M-9A0 (Calpella + N11P/M Discrete Graphic)

FOXCONN		HON HAI Precision Ind. Co., Ltd.	
		CCPBG - R&D Division	
Title ARD (CLK,MISC,JTAG)			
Size	Document Number	Rev	
Custom	M9A0 MP	1.1	
Date:	Thursday, November 19, 2009	Sheet	3 of 73

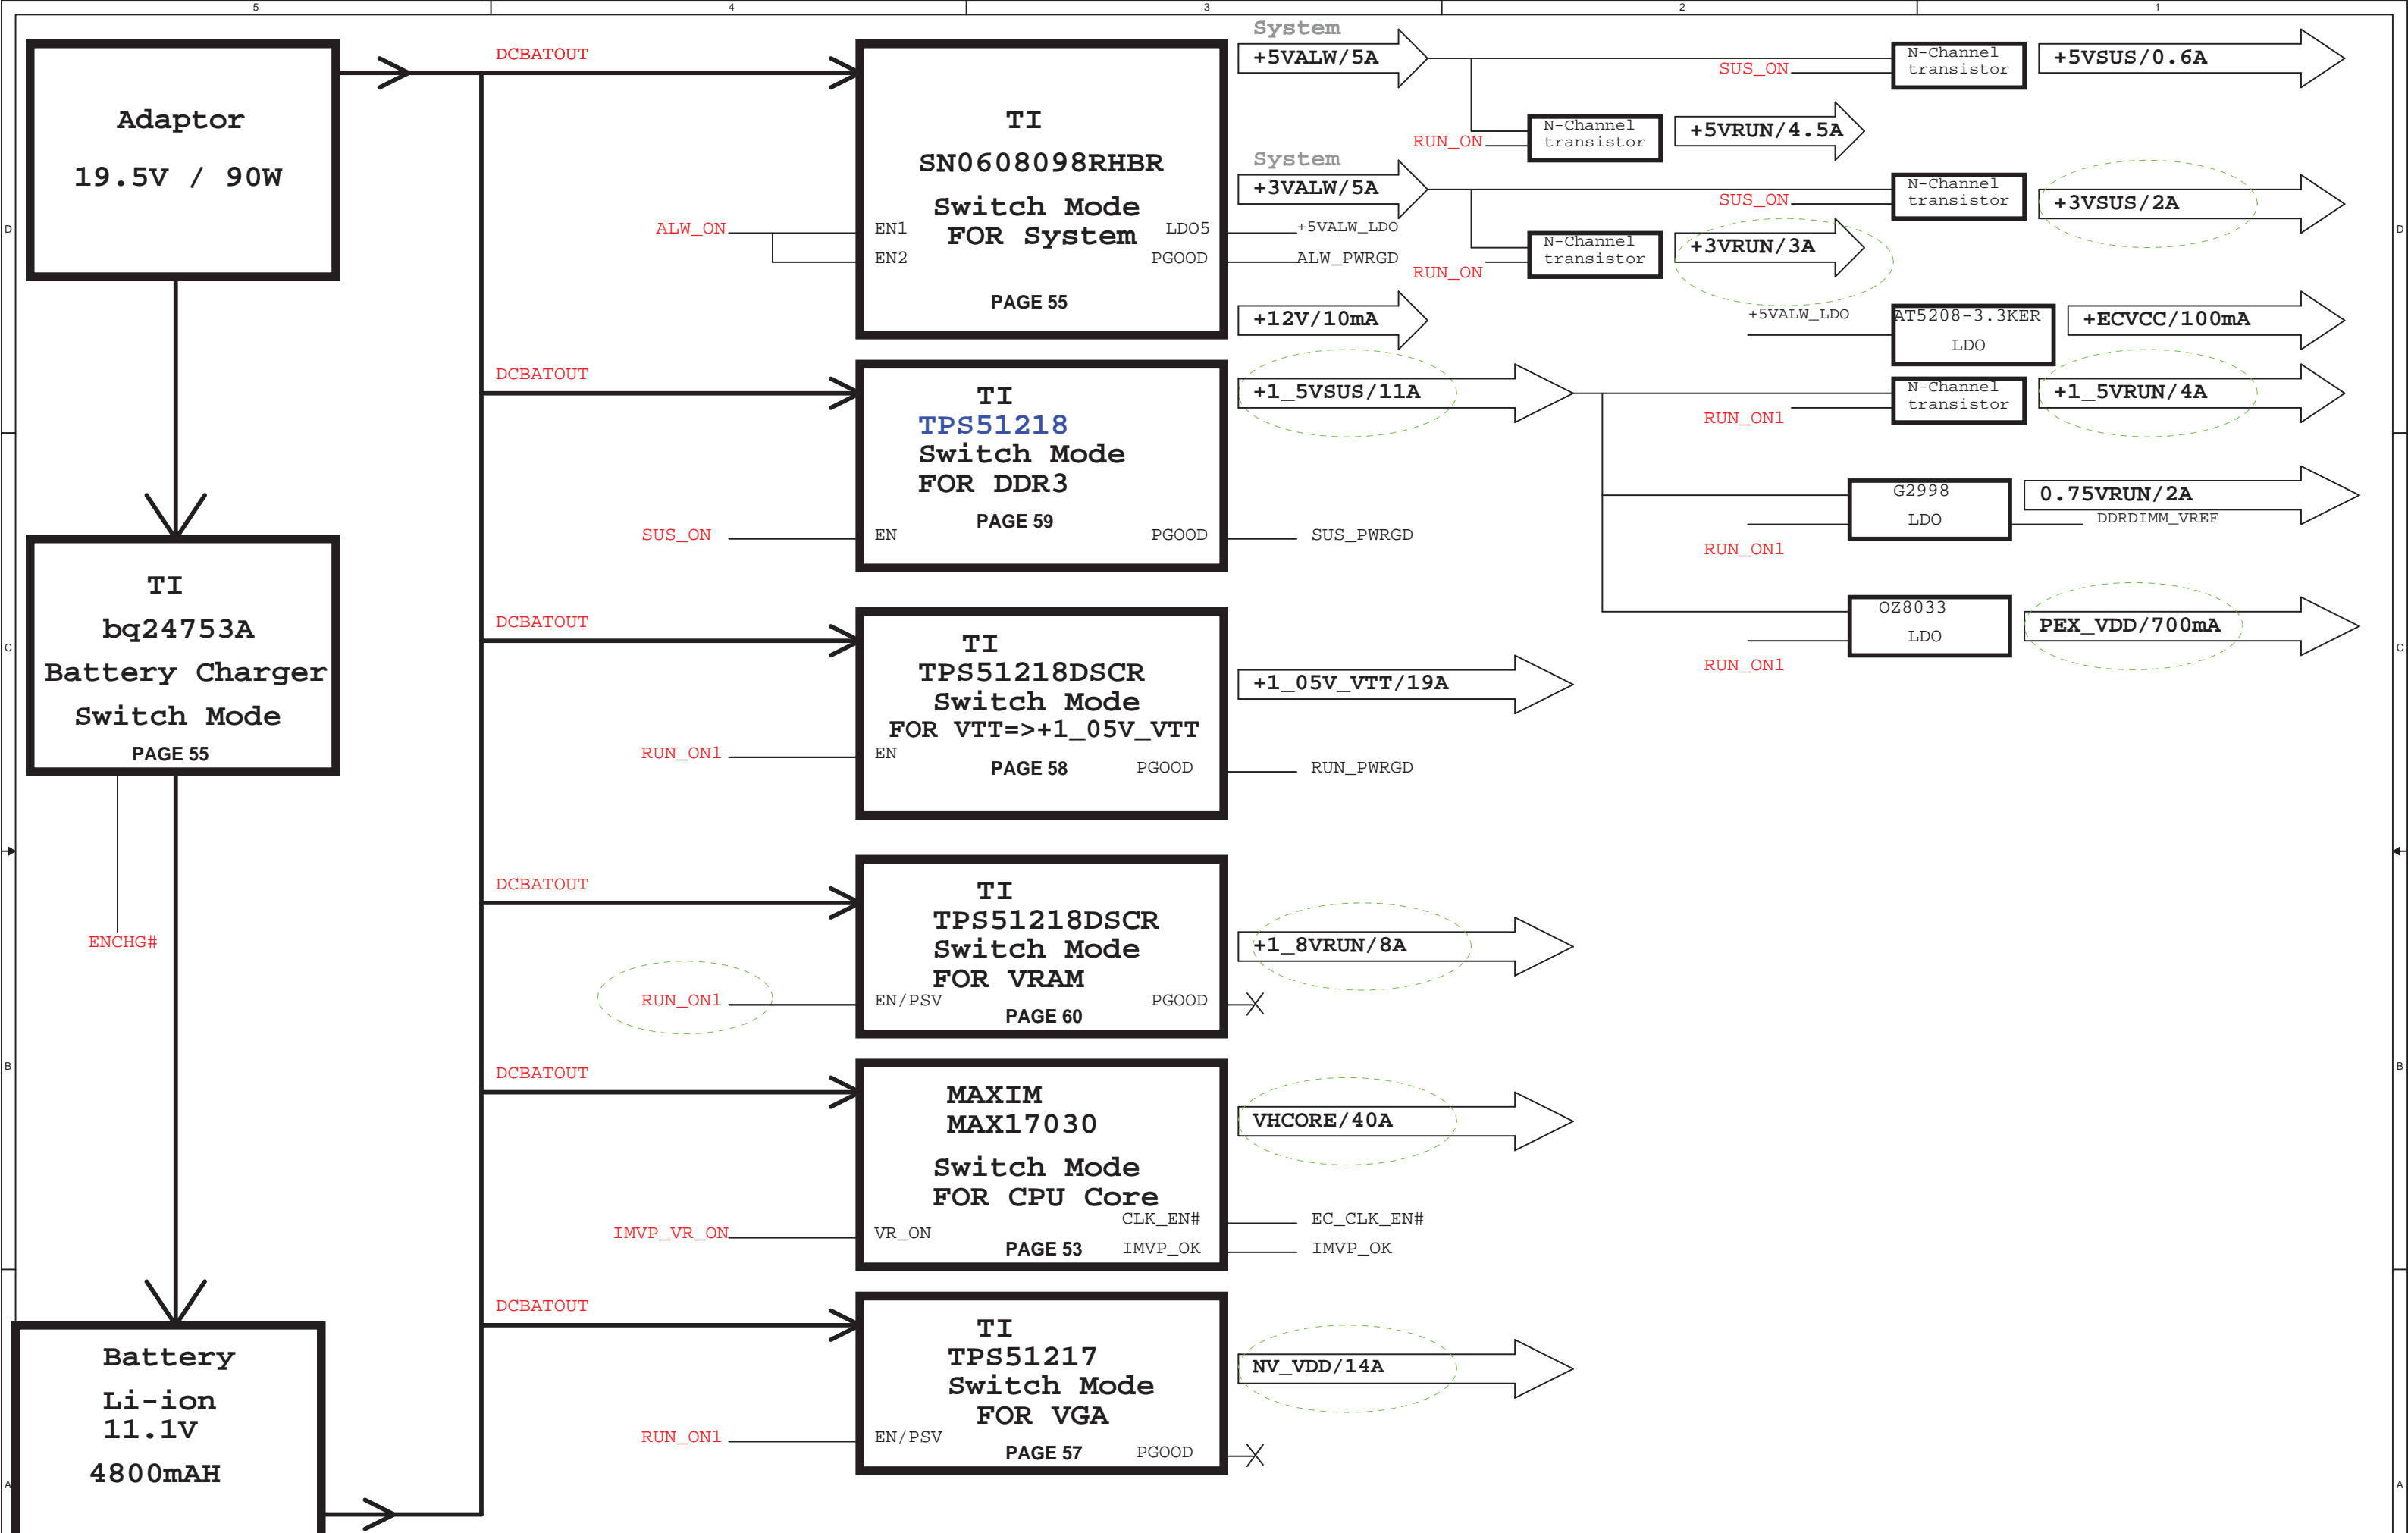
2009.10.30
change R5992,R5993,R5994 from 120ohm to 549ohm follow M870

2009.10.22
change PC112 from 68U to 47U for power request

Title: **SYS Power (+3_3V/+5V)**

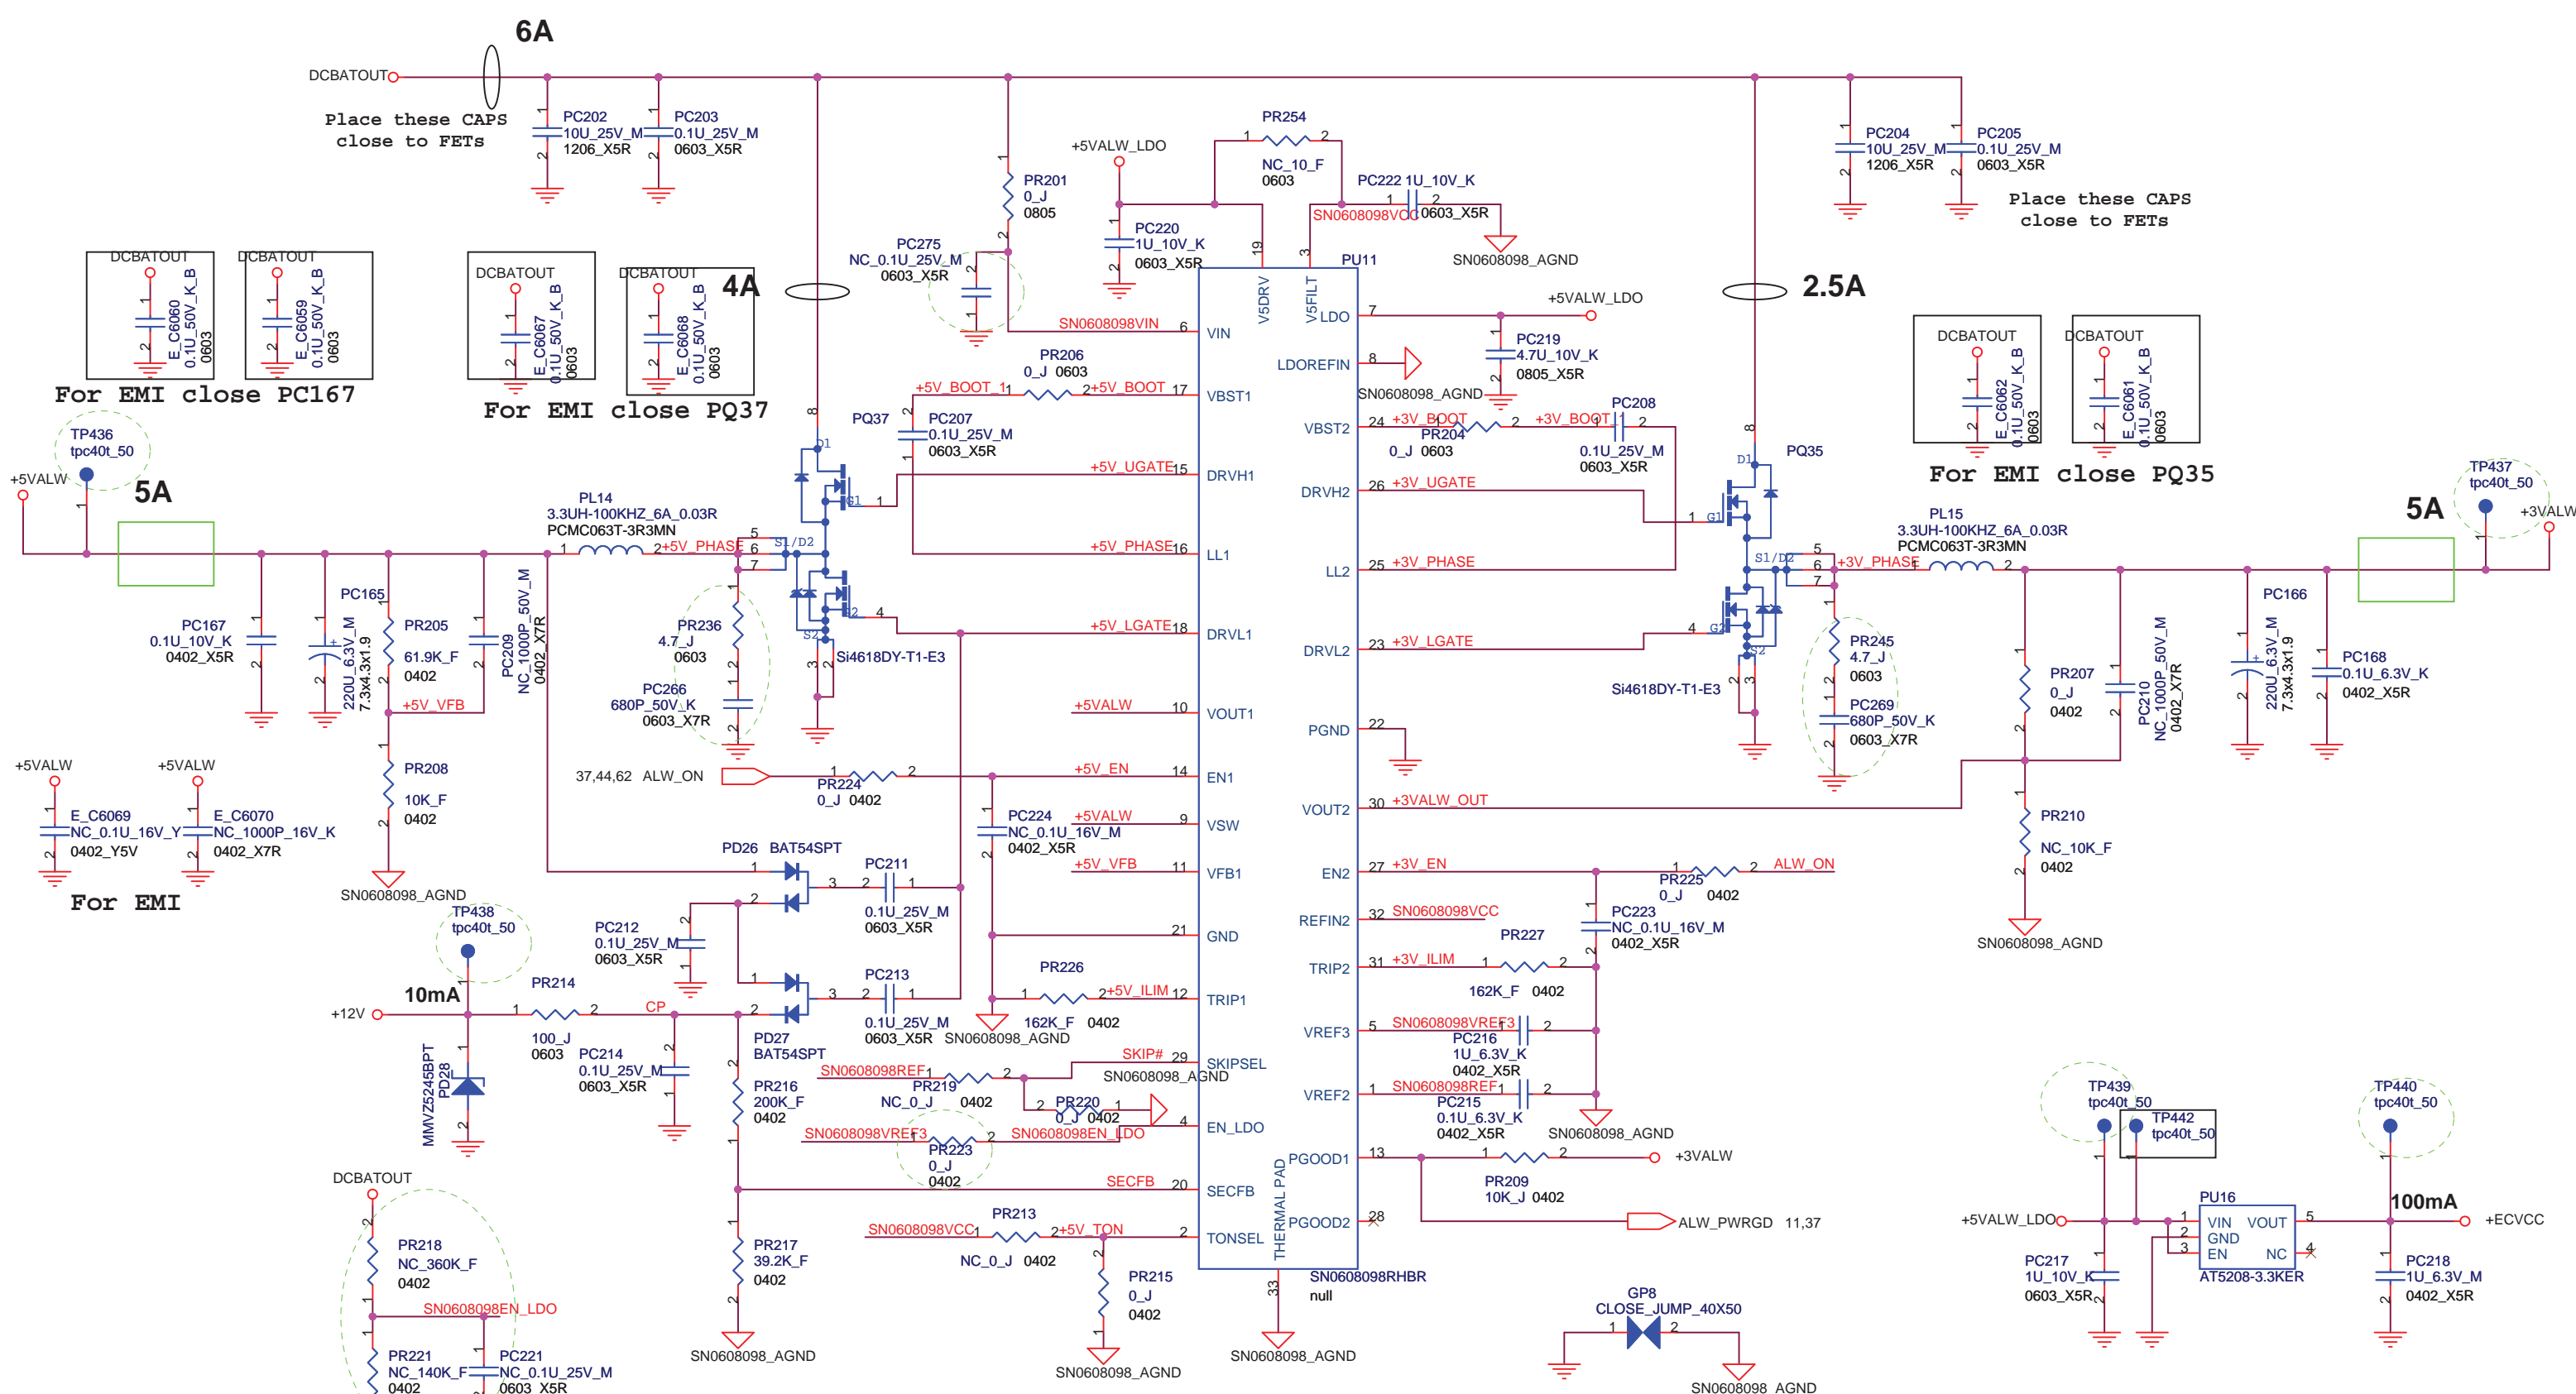
2009.0925
change PR245, PC269, PR236, PC266 from NC to mount for EMI request

FOXCONN		HON HAI Precision Ind. Co., Ltd.	
		CCPBG - R&D Division	
Title DDR3 Power(+1_5V/+0_75V)			
Size	Document Number	Rev	
Custom	M9A0_MP	1.1	
Date:	Wednesday, November 04, 2009	Sheet	58 of 73

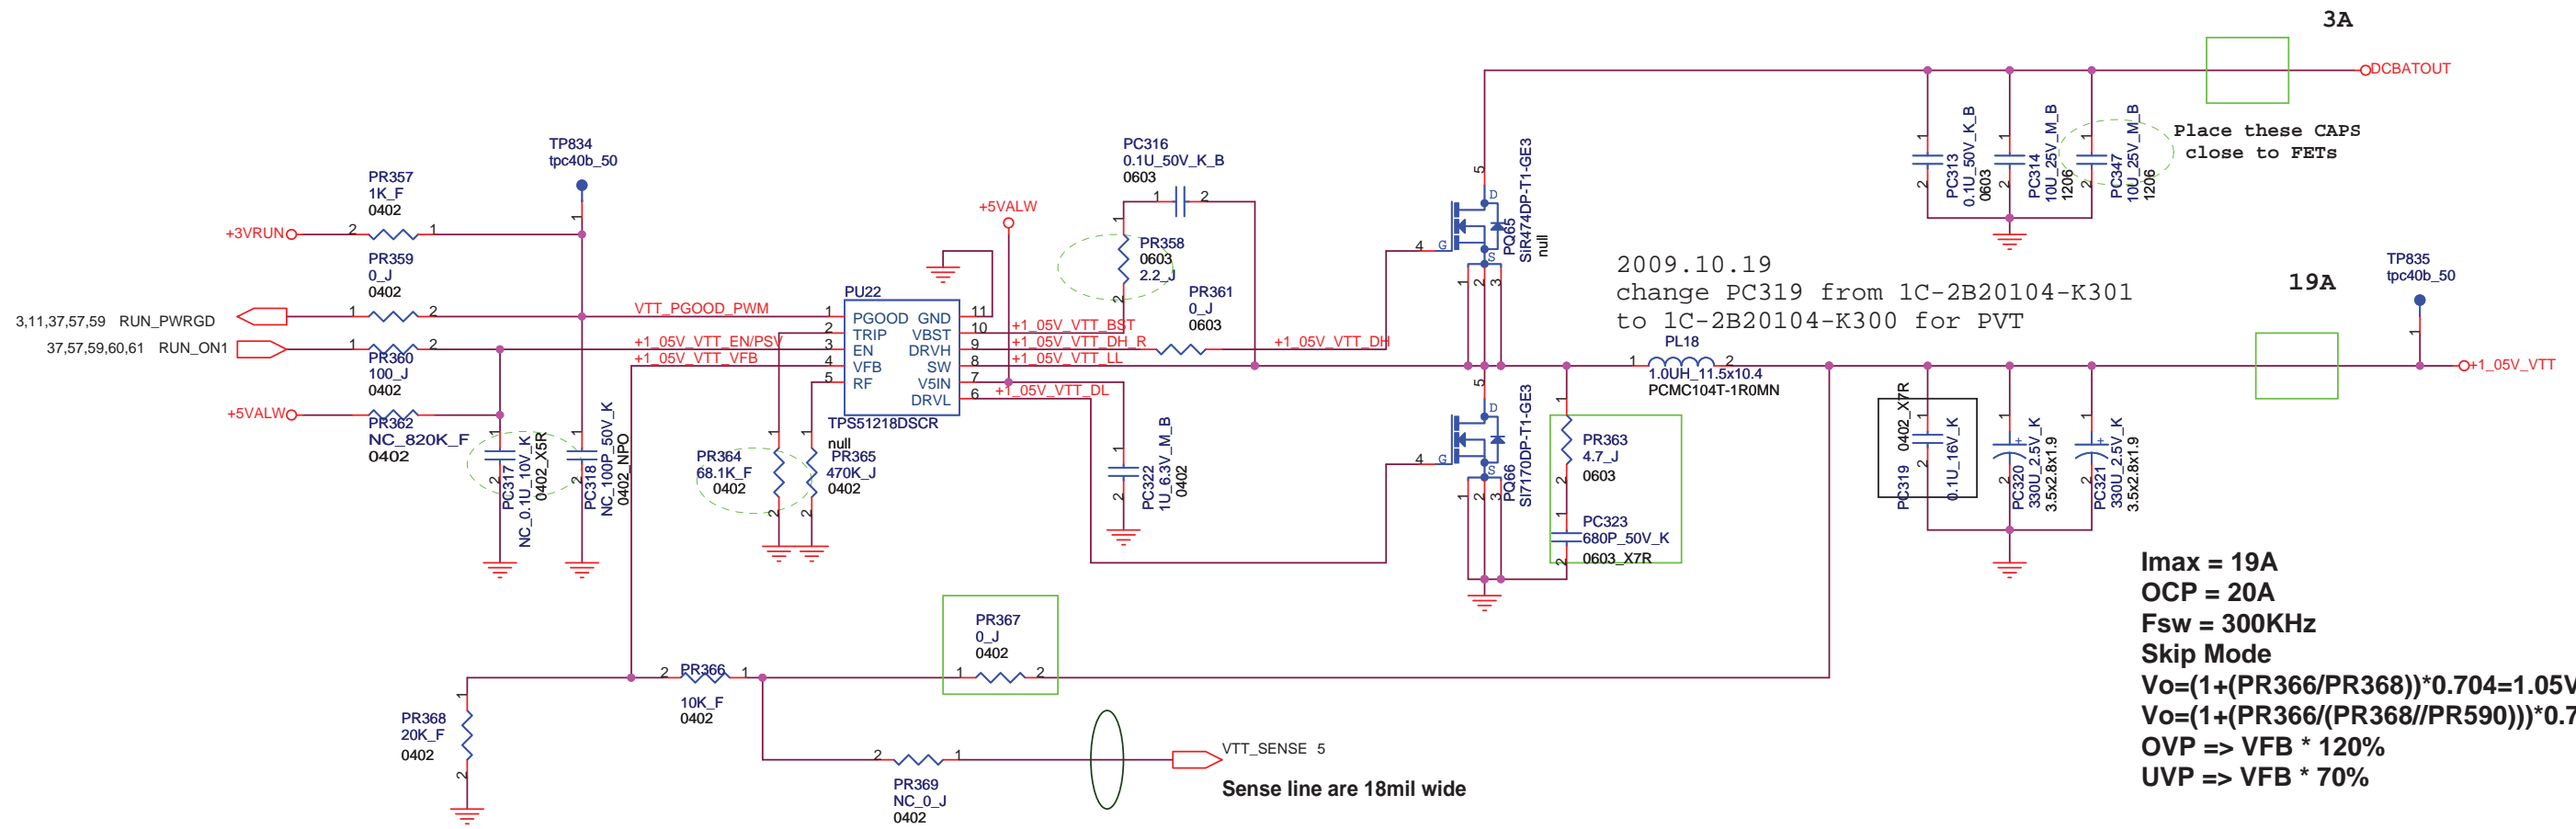
2009.10.19
change PC319 from 1C-2B20104-K301 to 1C-2B20104-K300 for PVT

2009.0925
change PR363, PC323 from NC to mount for EMI request
